HISTORIC LANDMARK COMMISSION
MAY 20, 2013
CERTIFICATE OF APPROPRIATENESS
LHD-2013-0003
4205 Avenue H
Hyde Park Local Historic District

Construct a new house on a lot with a two-story contributing garage.

1 NORTH ELEVATION

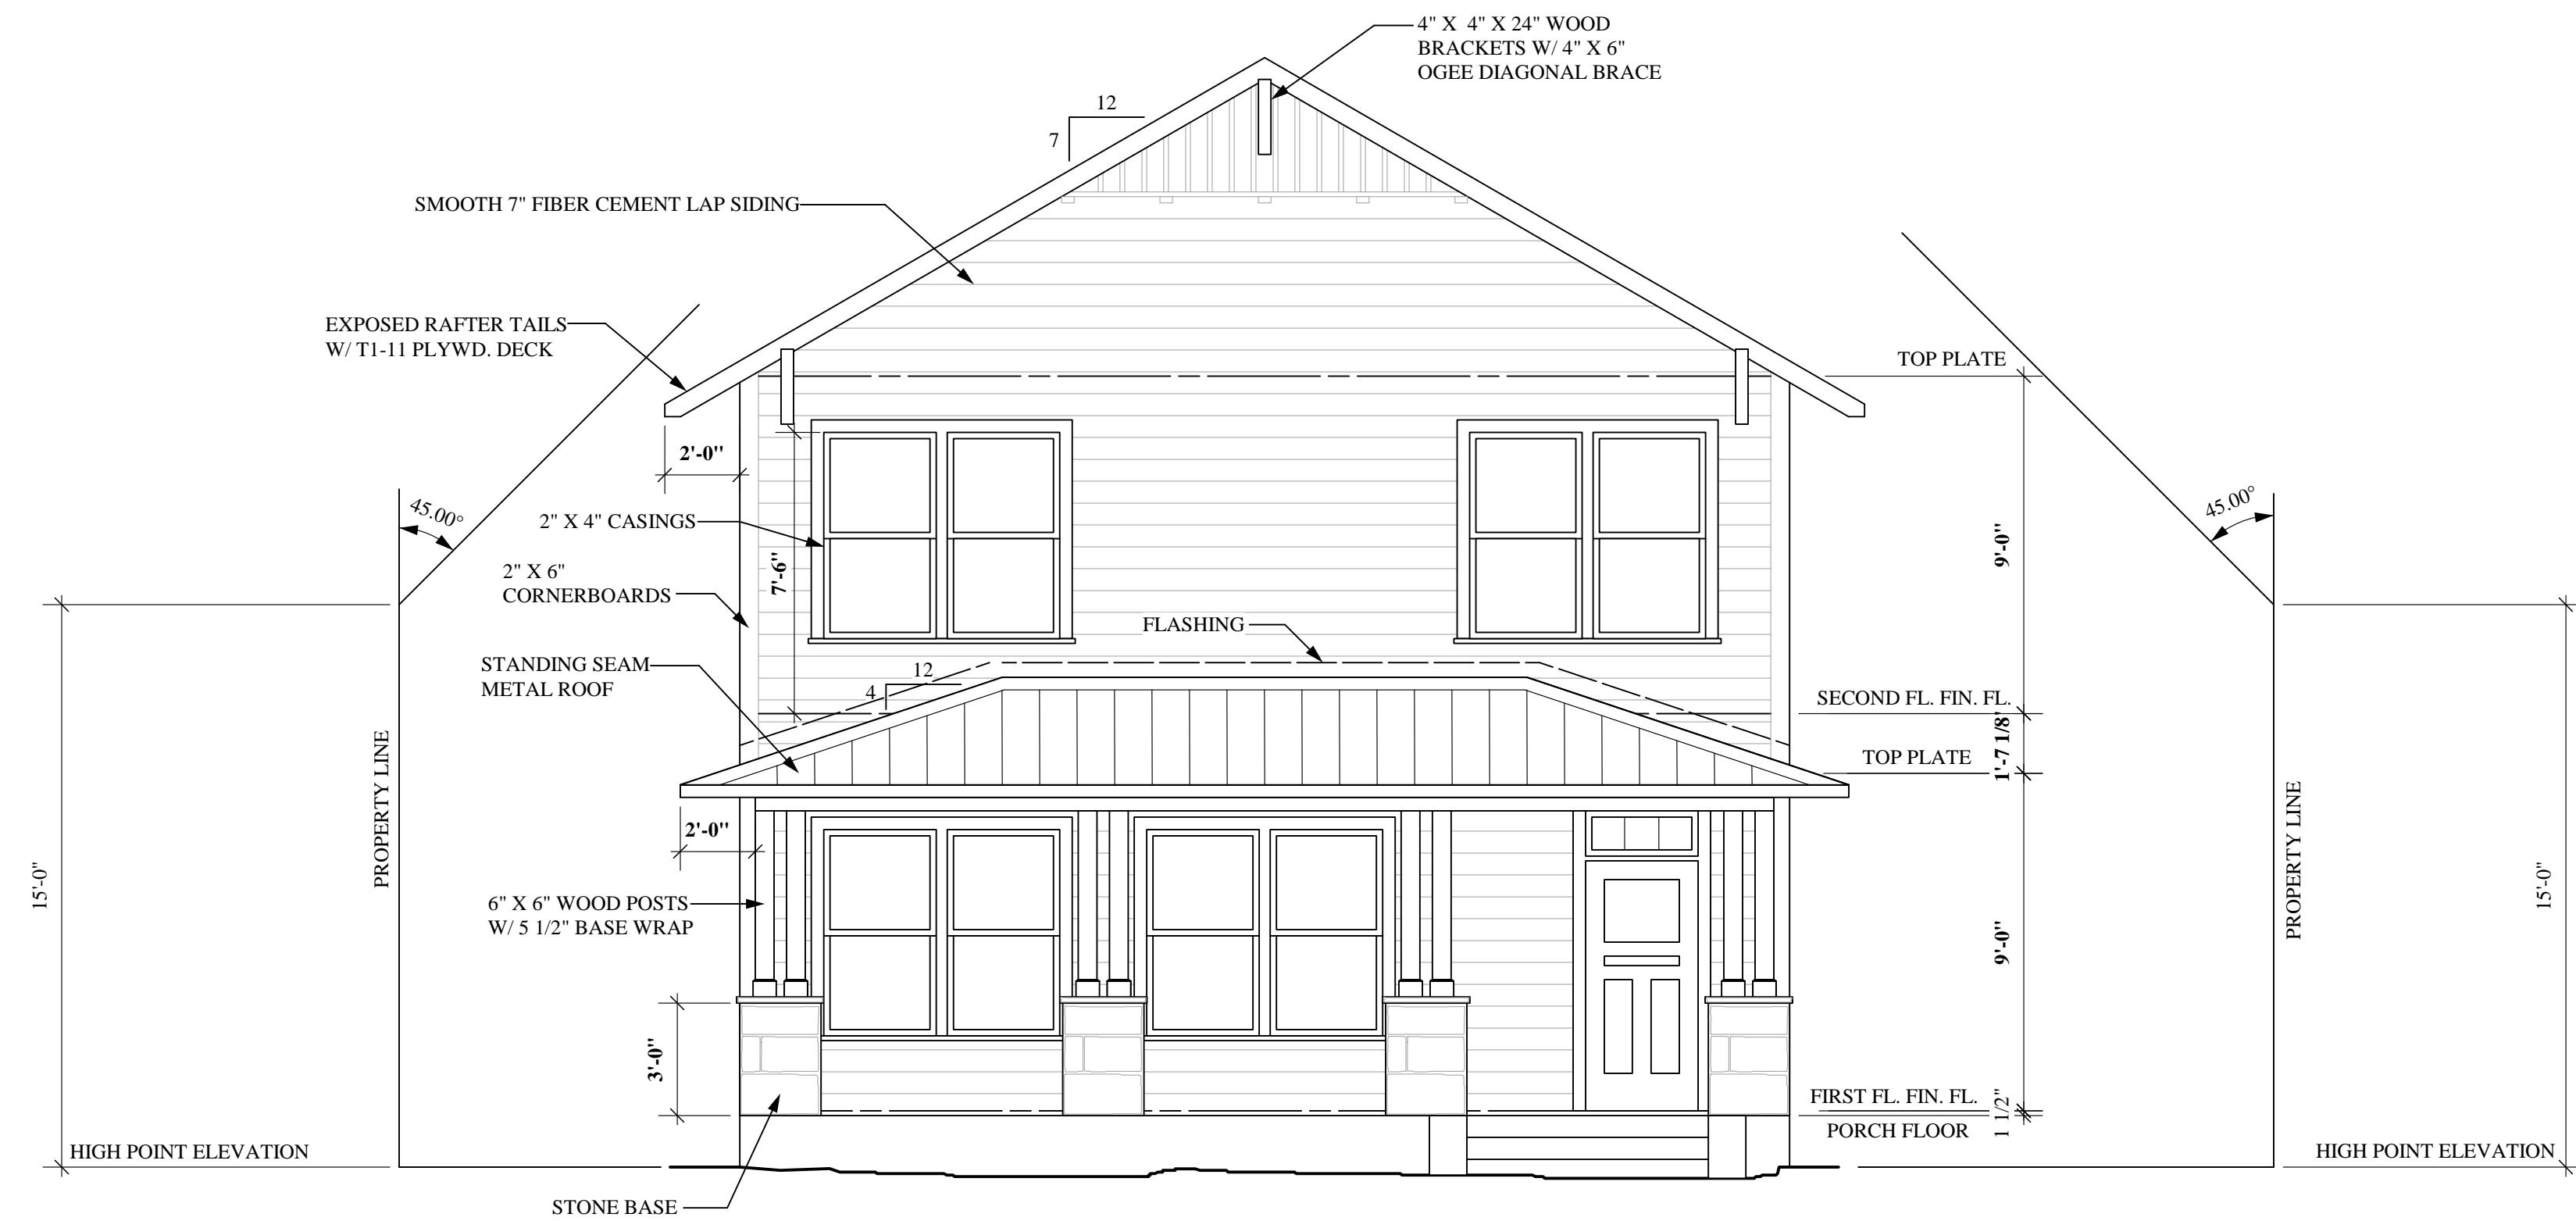
Provide casing trim between the pairs of double-hung windows to approximate weight pockets.

The applicant has incorporated the Certificate of Appropriateness Review Committee's recommendations to provide casing trim between the pairs of double-hung windows to approximate weight pockets.
